Installation of New ALPS Treated Water Dilution/ Discharge Facilities and Related facility

February 15, 2022

Tokyo Electric Power Company Holdings, Inc.

Responses to major issues* concerning the content of the application for the Discharge facility of ALPS Treated Water into the sea

Outline of the ALPS Treated Water dilution/discharge facilities operation

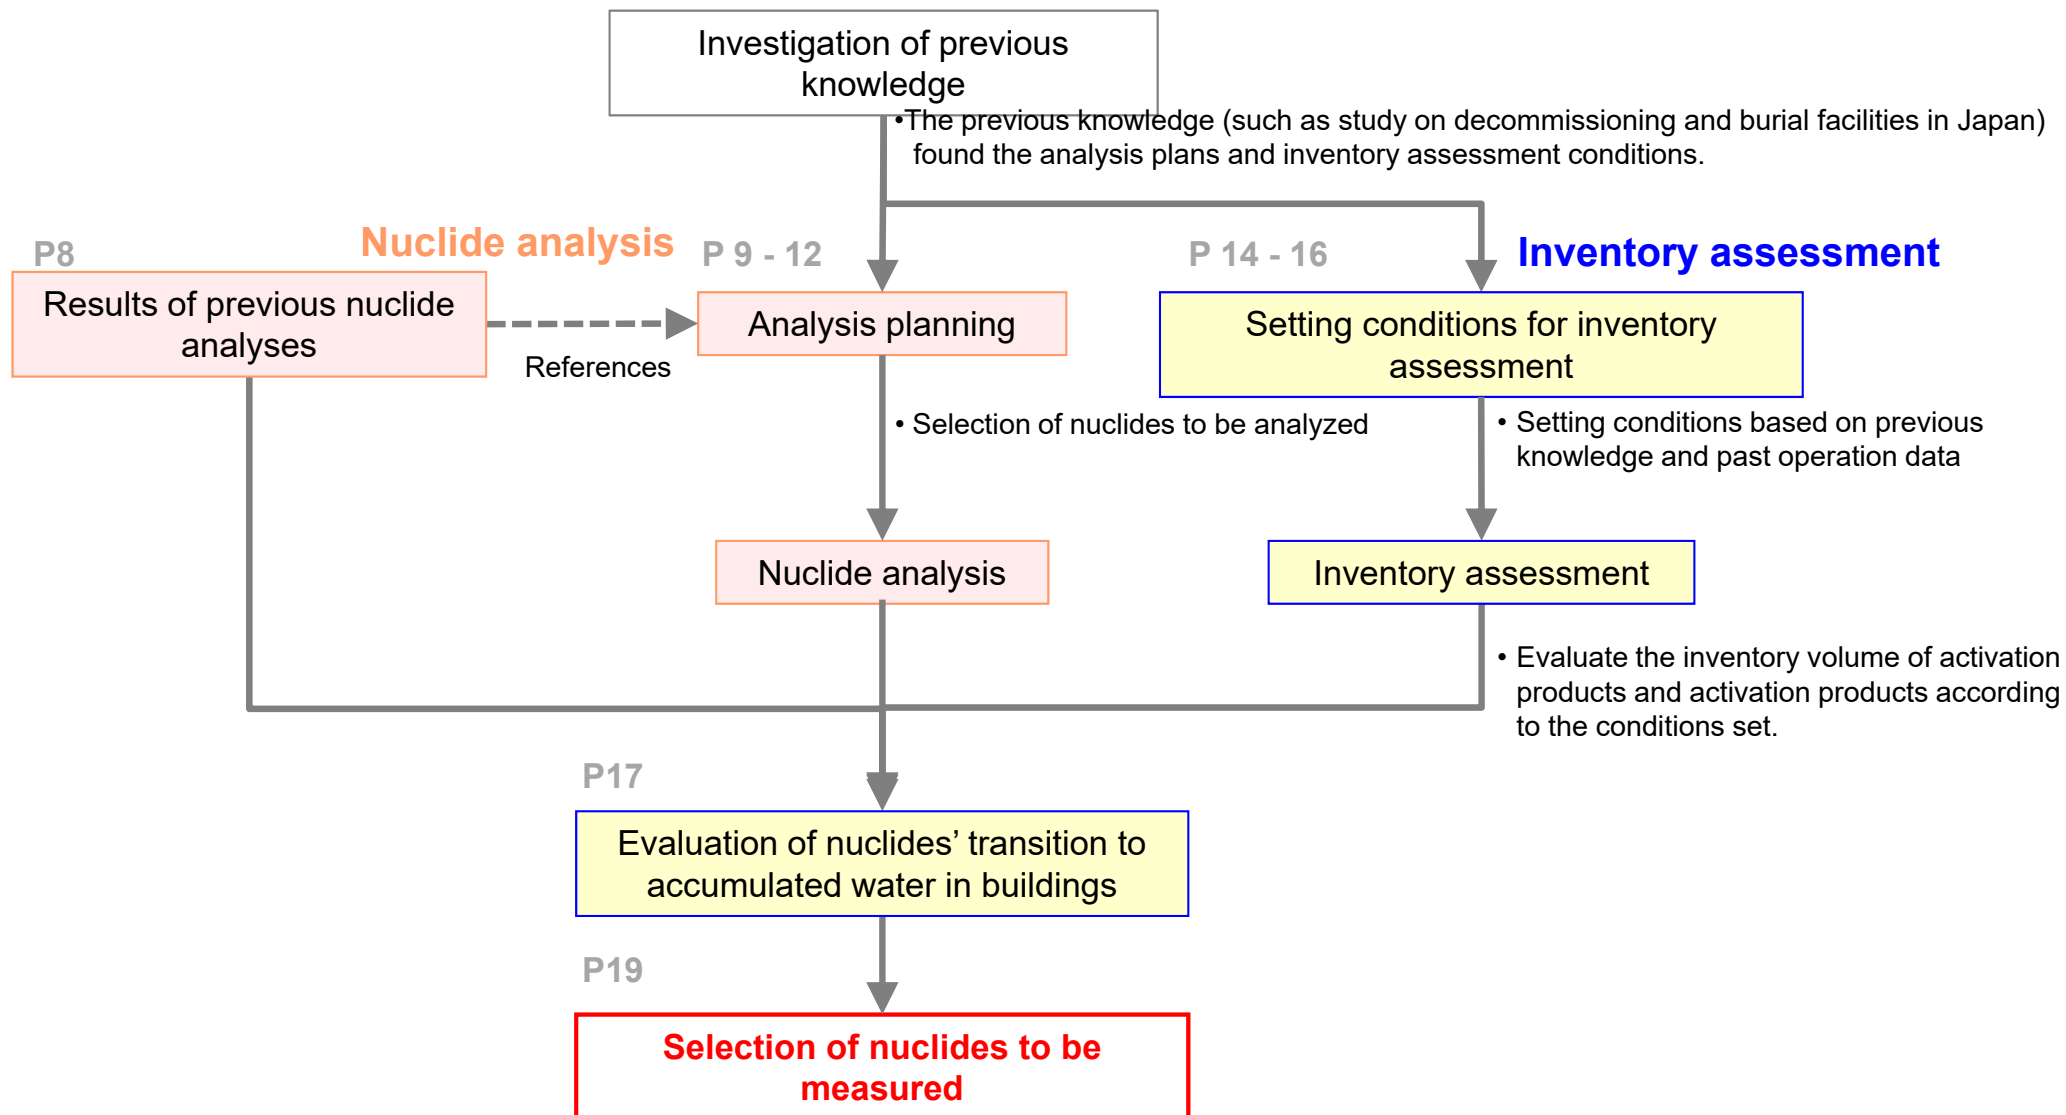
- Explain a policy for selecting nuclides that may affect dose assessment, other than tritium (H-3), carbon (C-14), and 62 nuclides to be removed by ALPS.

- In the discharge into the sea, we will thoroughly verify the nuclides that may be significantly contained in the accumulated water in buildings of the Fukushima Daiichi NPS (hereinafter referred to as “1F”) again. To be more specific, the study will be carried out on the following subjects:

- Considering the fuel and structural materials of units 1 - 3, we will first perform nuclide analysis and inventory assessment as below. Based on the results of the analysis and evaluation, as well as the effects on the dose assessment, we will select the nuclides to be measured at the time of discharge.

Current status

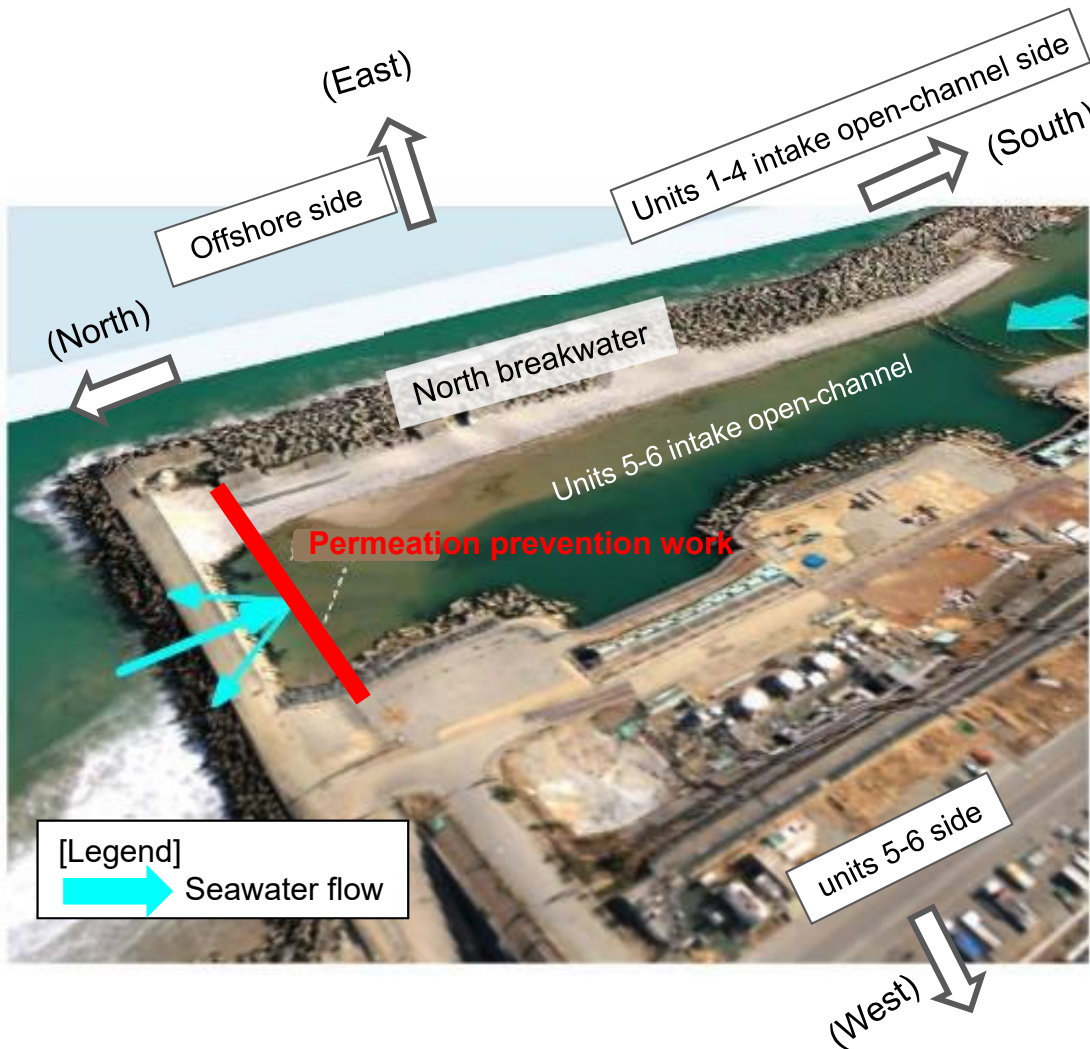
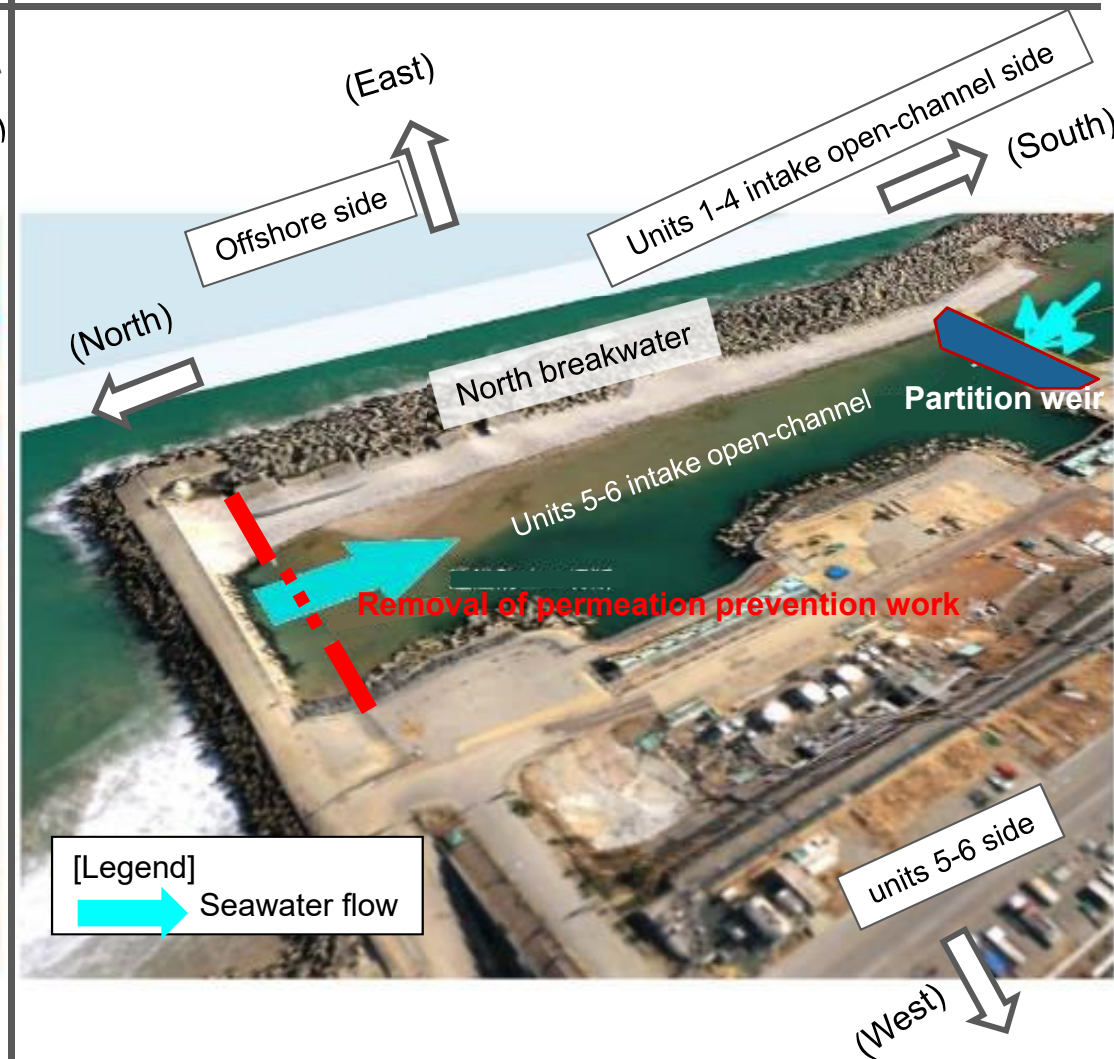
- When explaining the Discharge facility including water intake facilities, undersea tunnels, the concept of a partition weir and the transition rate to the seawater intake points should be presented.

- units 5-6 intake open-channel are shut with a partition weir (riprap sloping weir + sheet) from the units 1-4 side port. A part of the north breakwater permeation prevention work is remodeled so that the seawater for dilution is taken in from outside the port.
- Taking the seawater from outside the port by shutting from the port on the side of units 1-4, it is possible to suppress the drawing in of the seawater of a relatively high concentration of radioactive materials within the port.

4.5 Water intake method: Structure of partition weir

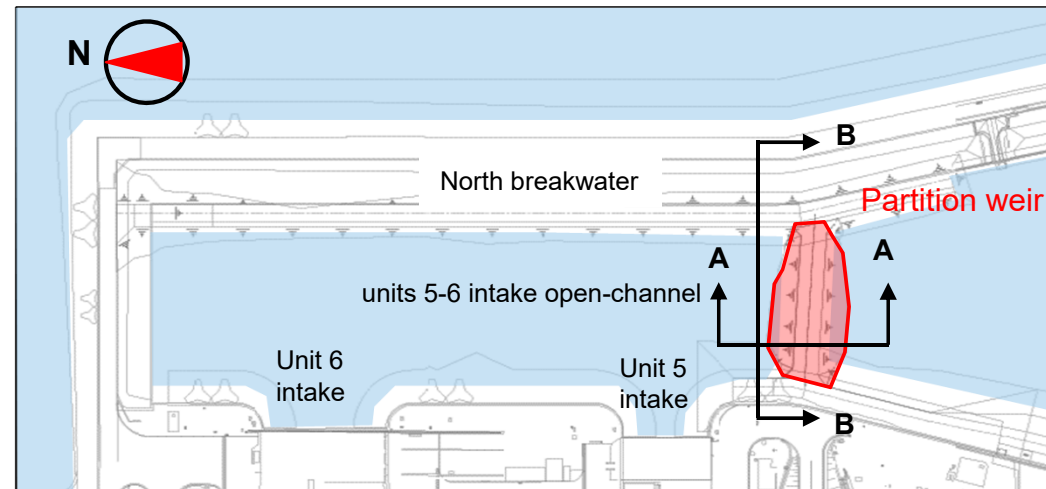
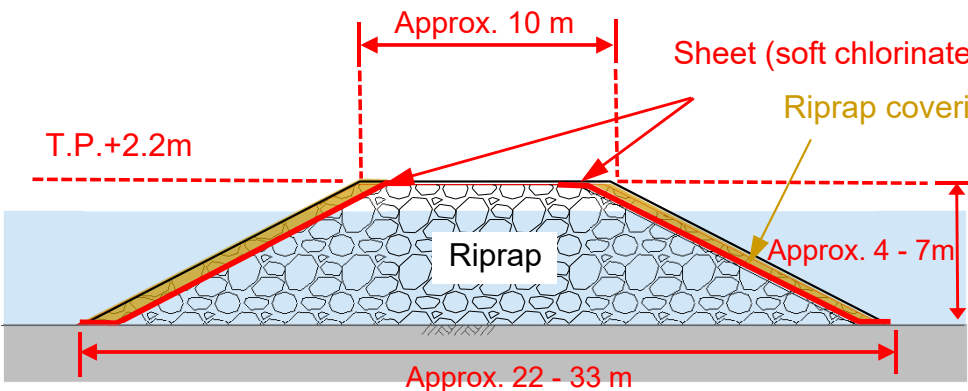
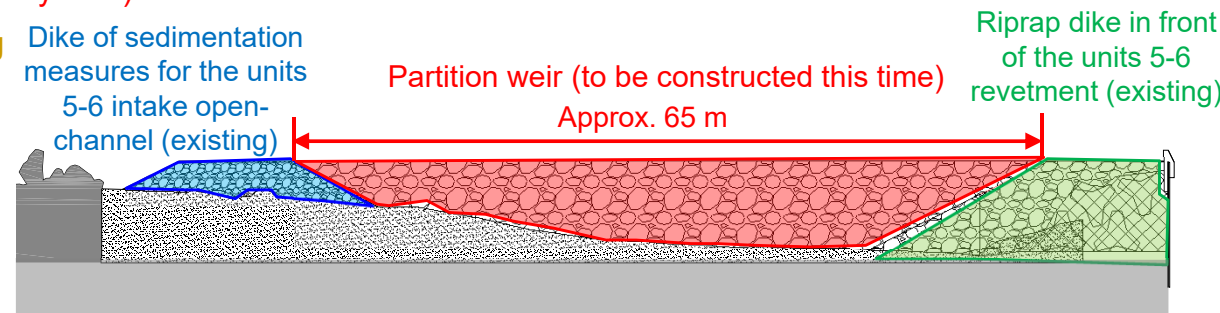
- In setting the mixing and diluting ratio as well as in assessing the effective dose at the site boundary, the effects of radioactive materials that may exist at the site of intaking seawater should be considered. When the impact cannot be disregarded, measures for preventing the transition of radioactive materials within the port to the intake site should be explained.

- The structural section of the partition weir is shown below:
- The height point of the top-end of the partition weir is the Tokyo Peil (T.P.) +2.2 m, which is higher than the condition of HHWL (the highest sea level in the past: T.P. + 1.15 m), and the inflow of seawater from the units 1-4 side can be avoidable.
